Product Change Notification (PCN)

PCN#: PCN-2023-031-05 rev1.0

Example: Device TLSR827X

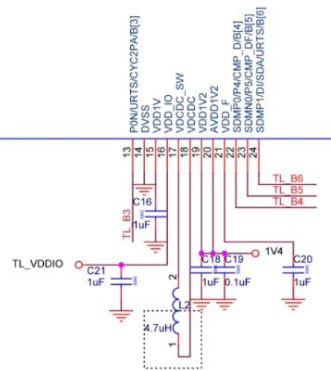
The chip embedded DCDC or LDO. If DCDC mode is adopted by customer, the reference inductor (L2 in below schematic) need be changed from 10uH to 4.7uH.

Change	Before	After
Inductor: L2	10uH	4.7uH

Both inductor and chip exist process variation which may decrease DCDC load capacity. Using 4.7uH inductor has stronger DCDC load capacity to cover inductor and chip process variation.
